ADDENDUM # 01

PROJECT: Evergreen Baptist Church – Phase 5

Evergreen Baptist Church
Phase 5
Broken Arrow, Oklahoma

Addendum NO.1
March 19, 2025

2 SECOND FLOOR LEVEL DEMO
1/8" = 1'-0"

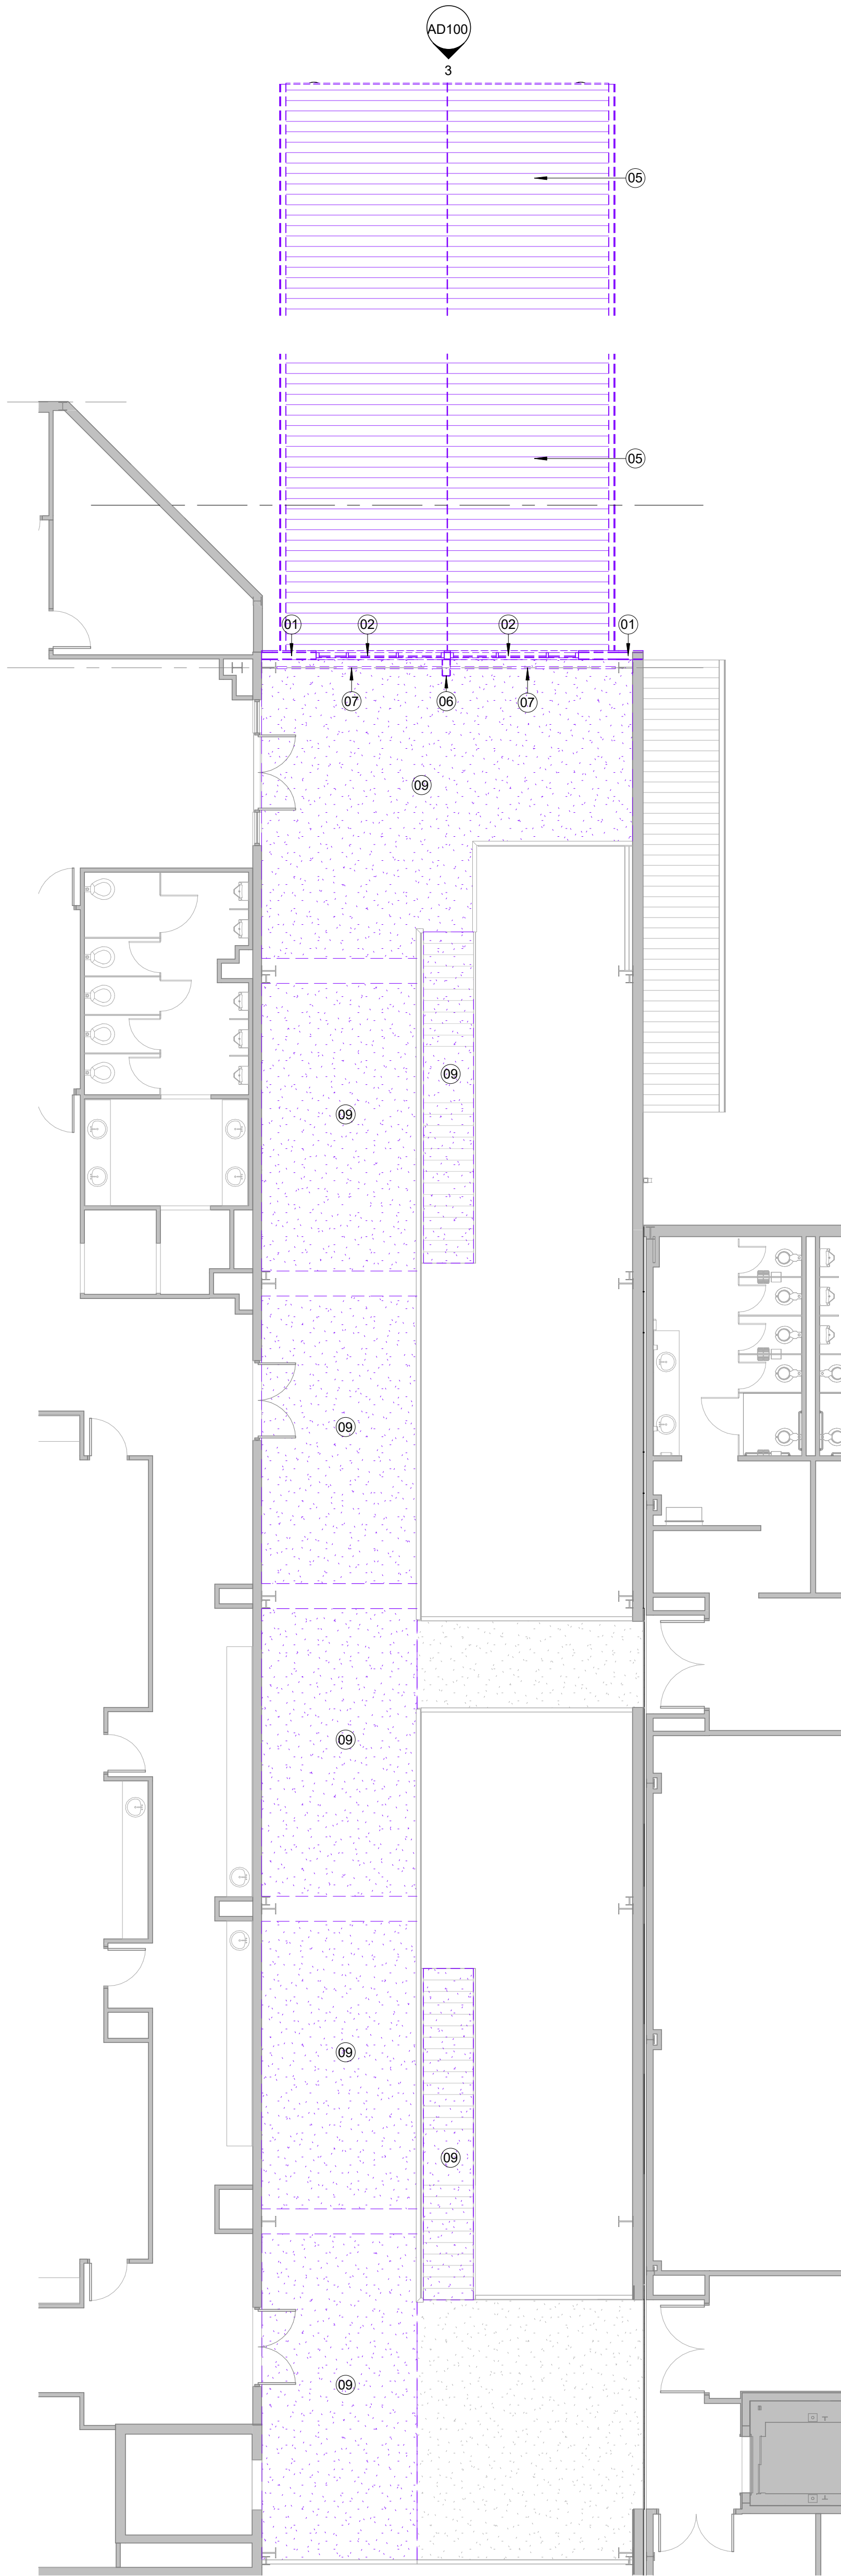
1. AD100 – ARCHITECTURAL DEMO PLAN – FIRST FLOOR OVERALL; Expanded Second Floor Demo Plan.
2. A102.2 – SECOND FLOOR FINISH PLAN: Added Phase 3 Second Floor Finish Plan.
3. A601 – DOOR AND DOOR FRAME SCHEDULES AND DETAILS: Added door hardware information to schedules; Removed Access Control on doors (225, 226.1 & 226.2)
4. A604 – INTERIOR SCHEDULES: Revised CPT5 in the Finish & Material Legend.
